To: Mr. Tim Johnson, American TCB
From: David Waitt, Airespace
Subject: Inquiries regarding Certification application for FCC ID **QTZVAP1200B**
Date: 1 April 2003

Tim,
Below are the replies to your inquiries regarding this application. The answers are numbered corresponding to your inquiries in your letter dated 24 March 2003. If something is unclear, or if you have additional concerns, please contact me.

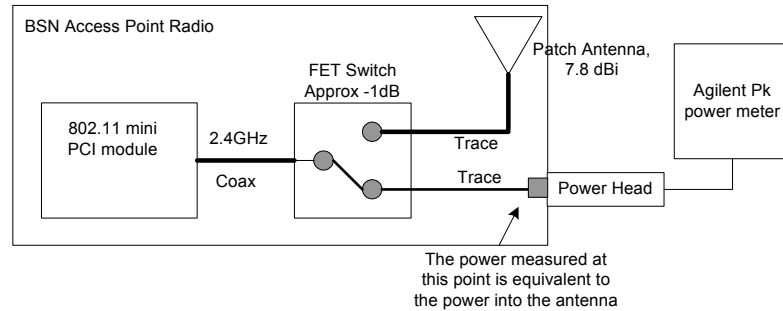
ATCB 5) The power measured shown on page 4 of the main report shows measuring at the antenna connector. However the RF exposure lists 6.8 dBi instead of 7.8 dBi gain for the antenna path which is assumed to be before the switch. Please confirm as the last application it was assumed to be measured before the switch. Please updated any exhibits affected.

Correct. The gain should have been 7.8 dBi in the MPE calculation, not 6.8 dBi. The MPE calculation has been re-done and uploaded to the ATCB site.
